Halifax Regional Council
November 20, 2007

SUBJECT: **Chebucto Road Reversing Lane Project**

INFORMATION REPORT

**CHEBUCTO ROAD
OPTION 2
ATTACHMENT B**

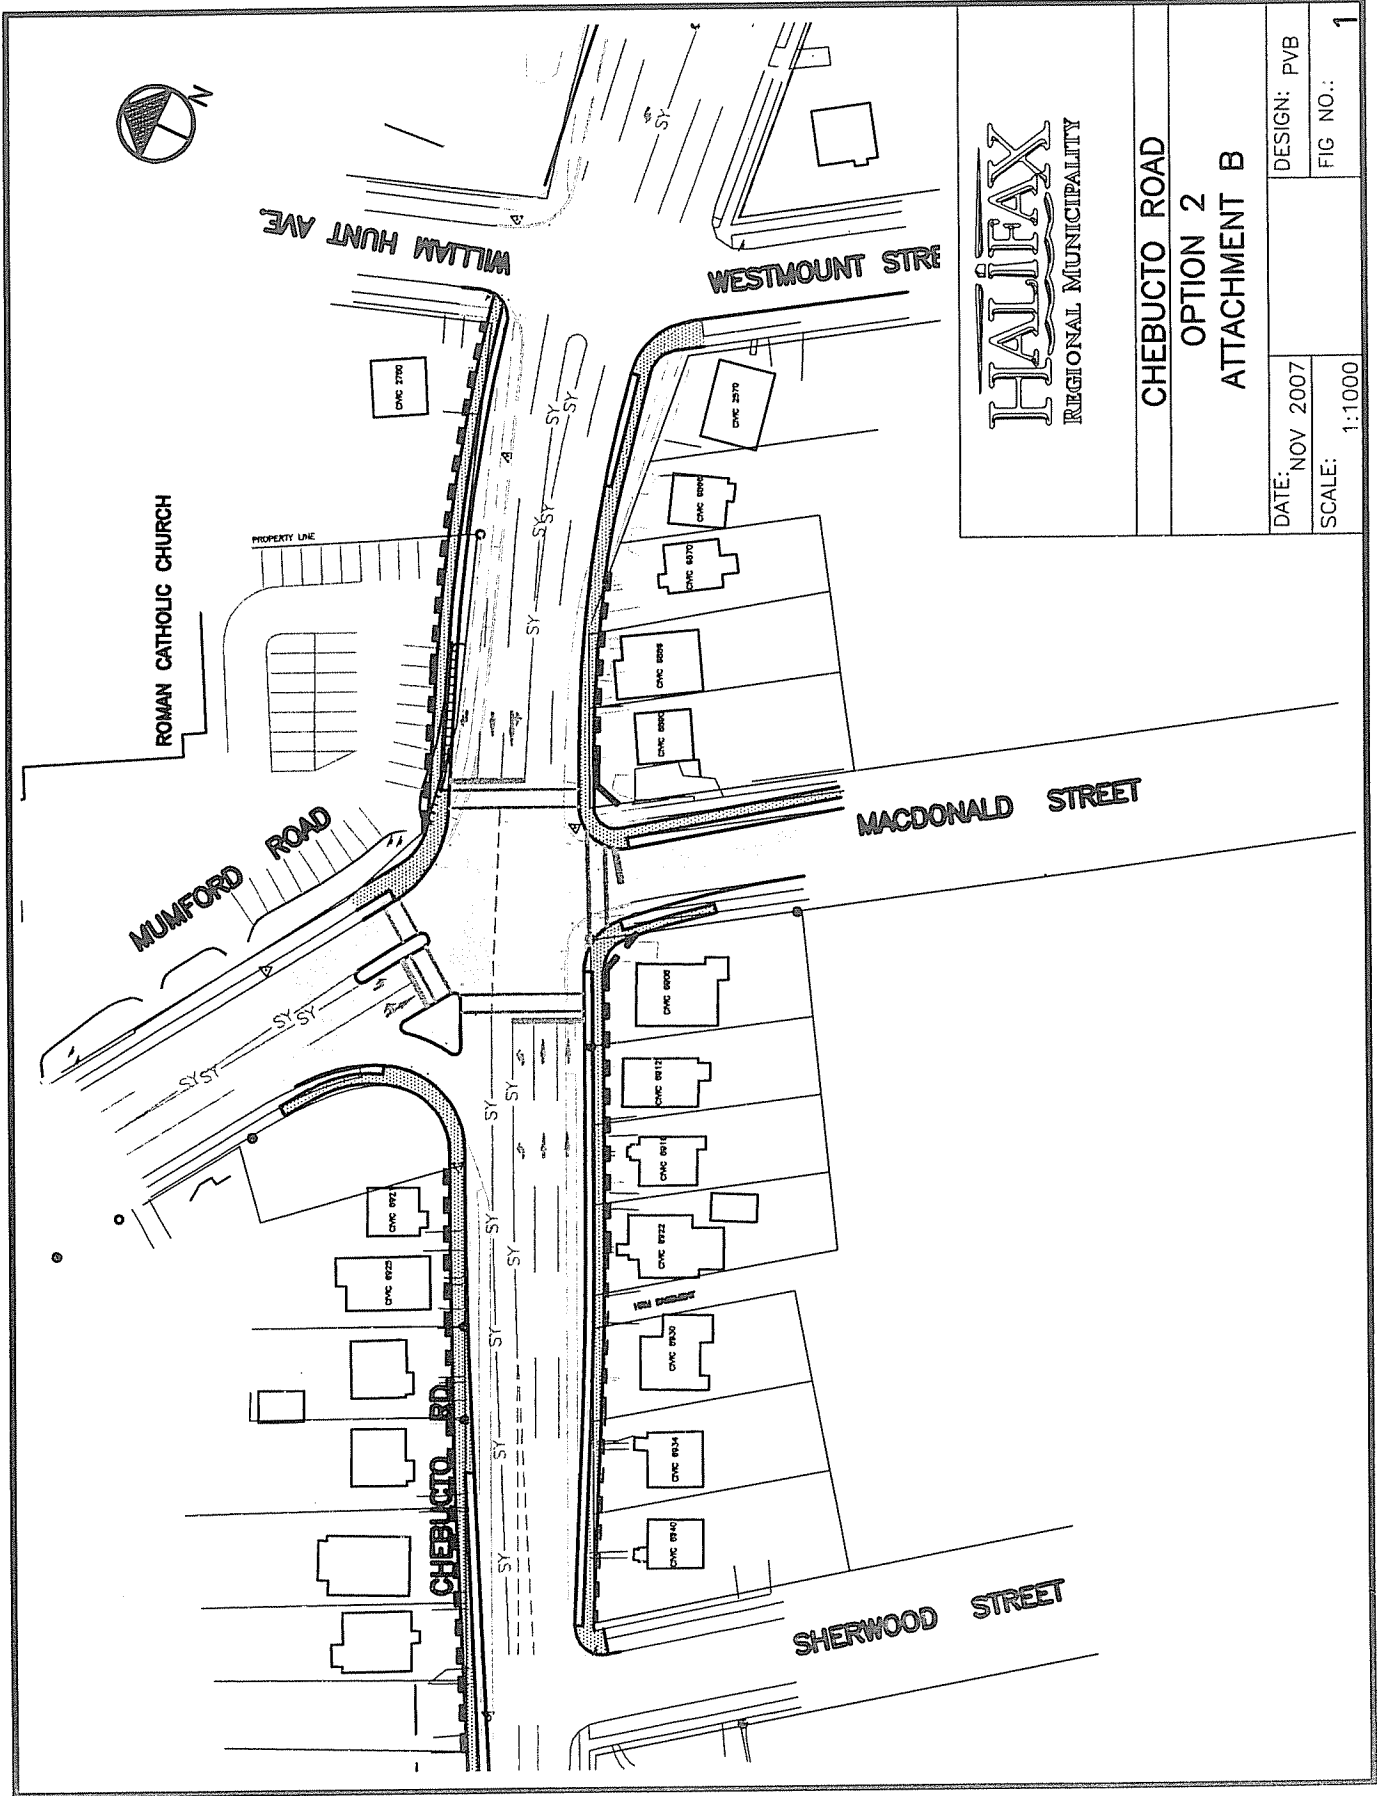
There was considerable opposition to this plan because of the degree of impact to the properties on the south side. In May 2007, staff met with the Chebucto Neighborhood Association and presented a second design option which would minimize the degree of impact. (see Attachment B). This plan required the partial taking of property from seventeen (17) residential properties on both sides of the street ranging from 4 to 9 feet. It also required a partial taking of property from St Agnes Catholic church but spared the residential property at Civic 6886. This design is referred to as Option 2.

**CHEBUCTO ROAD
OPTION 1A
ATTACHMENT D**

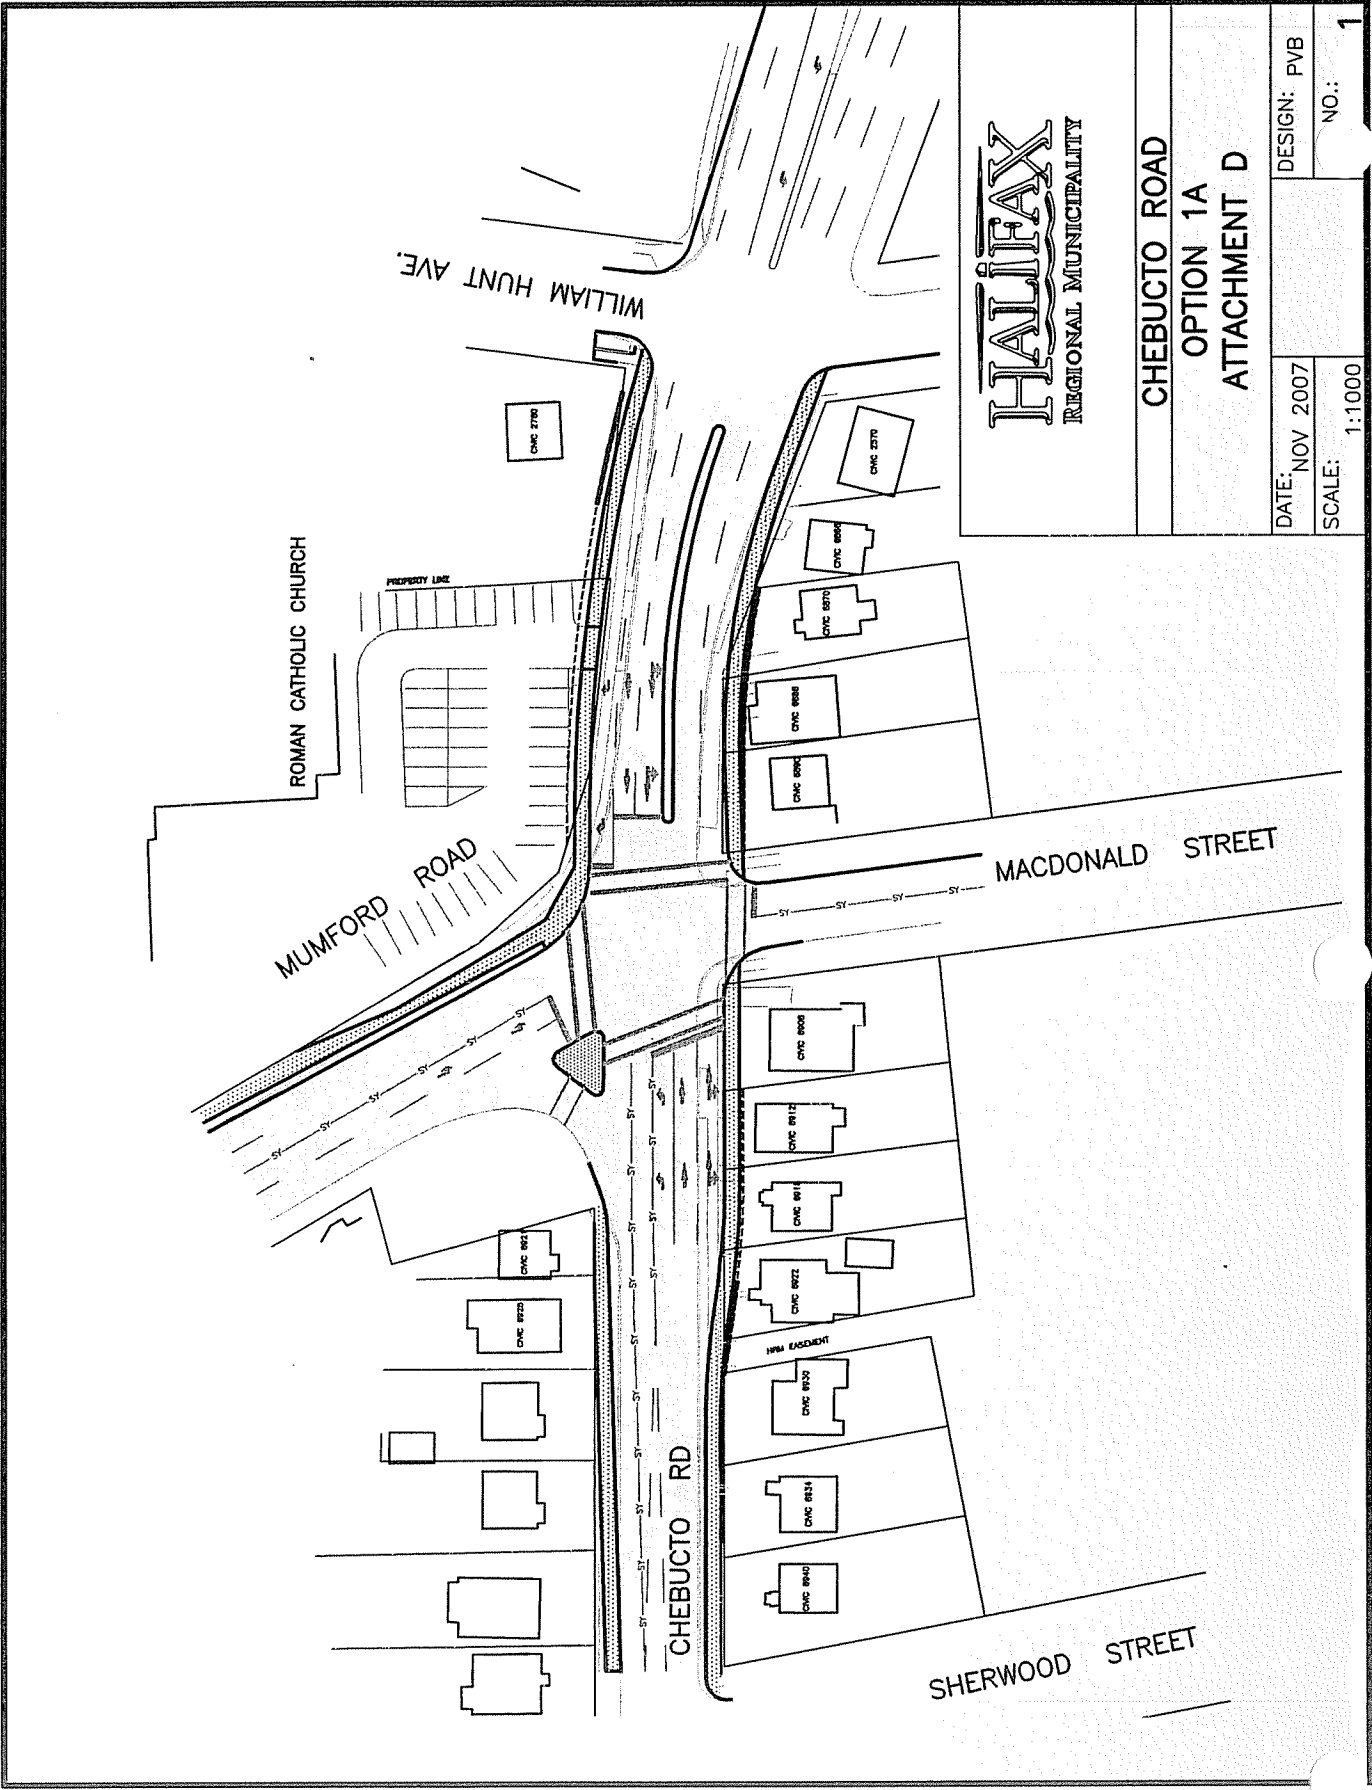
All of the proposals put forward over the past few years have called for the loss of some parking. Like other affected property owners we would like to see traffic handled in ways that is least disruptive. Ideally, that would be by maintaining the status quo which is always an option. Failing that, we would ask for the imposition of the least amount of disruption possible which appears to be a plan that was presented a year or so ago, which called for the loss of just 2 parking spaces.

The two "options" presented at the recent meeting call for the loss of up to 7 spaces, which when combined with the loss of 3 on street parking places on Chebucto Road, will have a considerable impact on our ability to serve those who use our property. If the project must proceed, then we would hope that it is designed in such a way as to reduce the amount of land required.

Some of the standard features included in street projects could be modified without causing any safety concerns. We would hope that the lanes be made as narrow as possible, that no grass median be placed between the curb and the sidewalk, that the

sidewalk be as narrow as safety will allow and that no land be reserved between the sidewalk and the church lands. Due to the limitations on the design of the parking spaces imposed by the shape of the church property even a few feet can have a major impact.

Based on the feedback received, staff conducted a review of the two design options which considered the number of properties affected, the degree of impact to each property, loss of street trees, and loss of parking to the church. A decision was made to proceed with Option 1. A modified design plan was prepared which requires the partial taking of property from seven (7) residential properties ranging from 2 to 10 feet. (See Attachment D) The residential property at Civic 6886 is avoided, and there is also a partial taking of property from St Agnes Catholic church. This design is referred to as Option 1A.
